Contract #: 04-0120F4Cty: SF/ALA Rte: 80 PM: 13.2/13.9File #: 69.25B**QUALITY ASSURANCE -- NON-CONFORMANCE REPORT****Location:** Changxing Island, Shanghai, P.R. China**Report No:** NCR-000564**Prime Contractor:** American Bridge/Fluor Enterprises, a JV**Date:** 16-Dec-2009**Submitting Contractor:** Zhenhua Port Machinery Company, Ltd (ZPMC), Changxing Island**NCR #:** ZPMC-0537**Type of problem:****Welding****Concrete****Other****Welding****Curing****Procedural****Bridge No:** 34-0006**Joint fit-up****Coating****Other****Component:** OBG Segment 10AW FL3**Procedural****Procedural****Description:****Reference Description:** Fabrication not according to the approved shop drawings in Segment 10AW**Description of Non-Conformance:**

To:	AMERICAN BRIDGE/FLUOR, A JV 375 BURMA ROAD OAKLAND CA 95607	Date:	25-Dec-2009
Dear:	Mr. Charles Kanapicki	Contract No:	04-0120F4 04-SF-80-13.2 / 13.9
Attention:	Mr. Thomas Nilsson Project/Fabrication Manager	Job Name:	SAS Superstructure
Subject:	NCR No. ZPMC-0537	Document No:	05.03.06-000525

Reference Description: Fabrication not according to the approved shop drawings in Segment 10AW

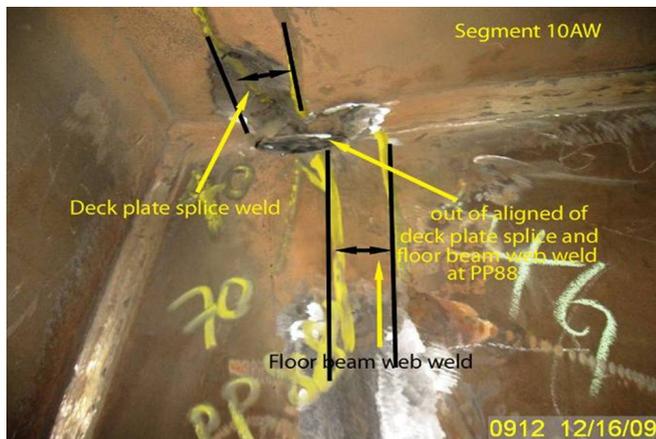
During random in-process visual inspection of OBG segment 10AW, Caltrans Quality Assurance (QA) Inspector discovered the following issues:

The complete joint penetration (CJP) weld joining the Deck panel diaphragm to the FL3 floor beam at panel points 86, 87 and 88 was found to be misaligned approximately 10 to 15mm with the weld access hole for the deck panel splice. The issue was explained by ZPMC QC Mr. Li Ming yang to be due to excessive cutting at fit up. Additional information identifying the weld and component location is listed below. The fabrication at these locations are not conforming to the approved shop drawings.

- Deck plate splice weld is identified as: SEG059*-010.
- The FL3 floor beam (FB19) to deck panel diaphragm weld at panel point 86 is designated as SSD10A-PP86-004.
- The FL3 floor beam (FB23) to deck panel diaphragm weld at panel point 87 is designated as SSD10A-PP87-004.
- The FL3 floor beam (FB27) to deck panel diaphragm weld at panel point 88 is designated as SSD10A-PP88-005.
- The OBG Segment 10AW is located inside the fabrication Bay 14.

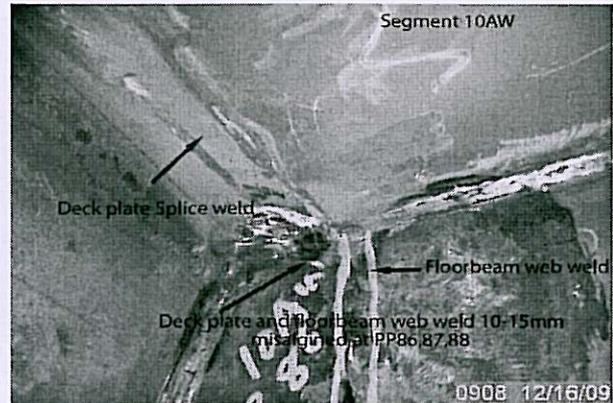
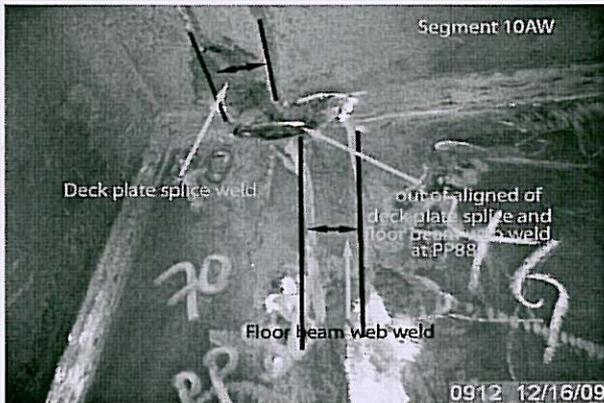
During random in-process visual inspection of OBG segment 10AW, Caltrans Quality Assurance (QA) Inspector discovered the following issues:

The complete joint penetration (CJP) weld joining the Deck panel diaphragm to the FL3 floor beam at panel points 86, 87 and 88 was found to be misaligned approximately 10 to 15mm with the weld access hole for the deck panel splice. The issue was explained by ZPMC QC Mr. Li Ming yang to be due to excessive cutting at fit up. Additional information identifying the weld and component location is listed below. The fabrication at these locations are not conforming to the approved shop drawings.

- Deck plate splice weld is identified as: SEG059*-010.
- The FL3 floor beam (FB19) to deck panel diaphragm weld at panel point 86 is designated as SSD10A-PP86-004.
- The FL3 floor beam (FB23) to deck panel diaphragm weld at panel point 87 is designated as SSD10A-PP87-004.
- The FL3 floor beam (FB27) to deck panel diaphragm weld at panel point 88 is designated as SSD10A-PP88-005.
- The OBG Segment 10AW is located inside the fabrication Bay 14.

Description of Non-Conformance:

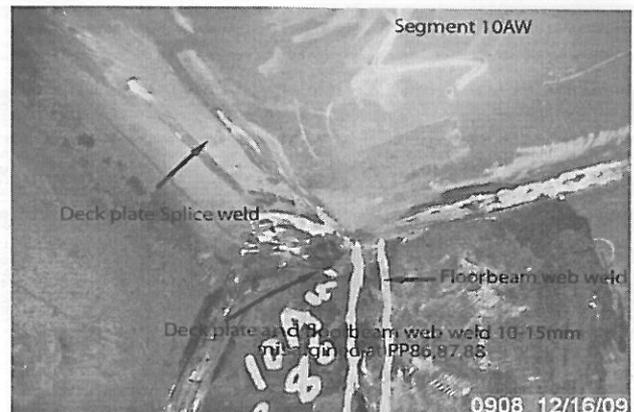
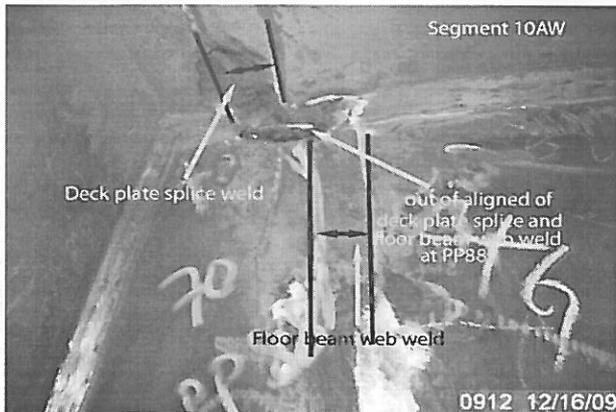
During random in-process visual inspection of OBG segment 10AW, Caltrans Quality Assurance (QA) Inspector discovered the following issues:

The complete joint penetration (CJP) weld joining the Deck panel diaphragm to the FL3 floor beam at panel points 86, 87 and 88 was found to be misaligned approximately 10 to 15mm with the weld access hole for the deck panel splice. The issue was explained by ZPMC QC Mr. Li Ming yang to be due to excessive cutting at fit up. Additional information identifying the weld and component location is listed below. The fabrication at these locations are not conforming to the approved shop drawings.

- Deck plate splice weld is identified as: SEG059*-010.
- The FL3 floor beam (FB19) to deck panel diaphragm weld at panel point 86 is designated as SSD10A-PP86-004.
- The FL3 floor beam (FB23) to deck panel diaphragm weld at panel point 87 is designated as SSD10A-PP87-004.
- The FL3 floor beam (FB27) to deck panel diaphragm weld at panel point 88 is designated as SSD10A-PP88-005.
- The OBG Segment 10AW is located inside the fabrication Bay 14.

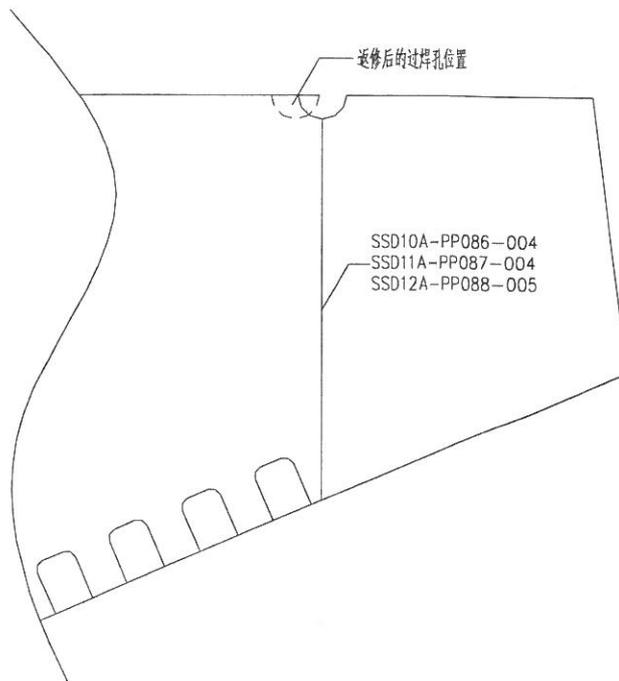
经检查发现箱梁10AW顶板连接板与隔板对接焊缝处的过焊孔与顶板拼接焊缝有错位,最大18mm。具体见下图。

Cope hole was offset with the deck connection plate of Segment 10AW by 18mm in maximum. Please see the details in the following sketch.

- 1, 返修前打磨返修区域光滑, 并按照WPS要求准备焊接接头;
- 2, 清除杂物, 并VT检测无缺陷和杂质存在;
- 3, 根据WPS要求进行预热及堆焊修补;
- 4, 焊后将焊缝打磨与周围母材齐平;
- 5, 返修后对修补区域进行VT和MT检测。

- 1, Before repair, grind the repair area to a smooth finish and prepare right excavation according to approved repair WPS.
- 2, Clean weld of all loose debris.
- 3, Preheat and weld according to the repair WPS.
- 4, Grind the repair area flush with base metal.
- 5, Perform VT and MT to the repair area.

Description of Non-Conformance:

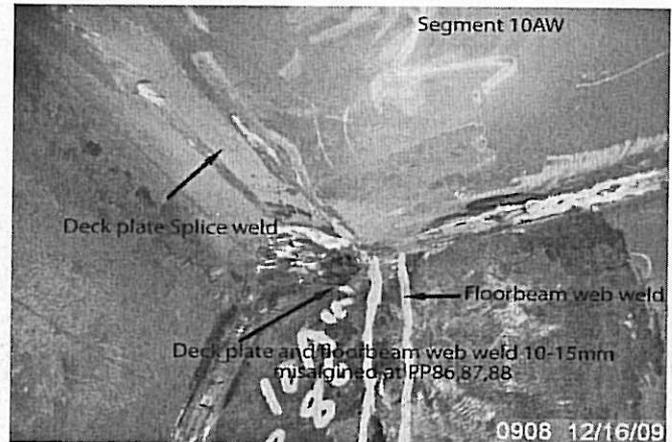
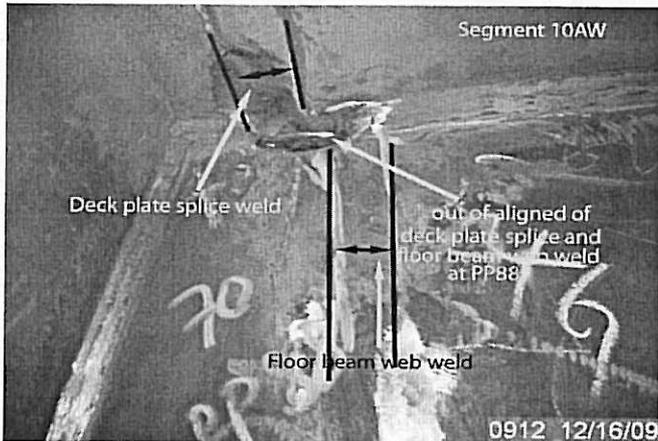
During random in-process visual inspection of OBG segment 10AW, Caltrans Quality Assurance (QA) Inspector discovered the following issues:

The complete joint penetration (CJP) weld joining the Deck panel diaphragm to the FL3 floor beam at panel points 86, 87 and 88 was found to be misaligned approximately 10 to 15mm with the weld access hole for the deck panel splice. The issue was explained by ZPMC QC Mr. Li Ming yang to be due to excessive cutting at fit up. Additional information identifying the weld and component location is listed below. The fabrication at these locations are not conforming to the approved shop drawings.

- Deck plate splice weld is identified as: SEG059*-010.
- The FL3 floor beam (FB19) to deck panel diaphragm weld at panel point 86 is designated as SSD10A-PP86-004.
- The FL3 floor beam (FB23) to deck panel diaphragm weld at panel point 87 is designated as SSD10A-PP87-004.
- The FL3 floor beam (FB27) to deck panel diaphragm weld at panel point 88 is designated as SSD10A-PP88-005.
- The OBG Segment 10AW is located inside the fabrication Bay 14.
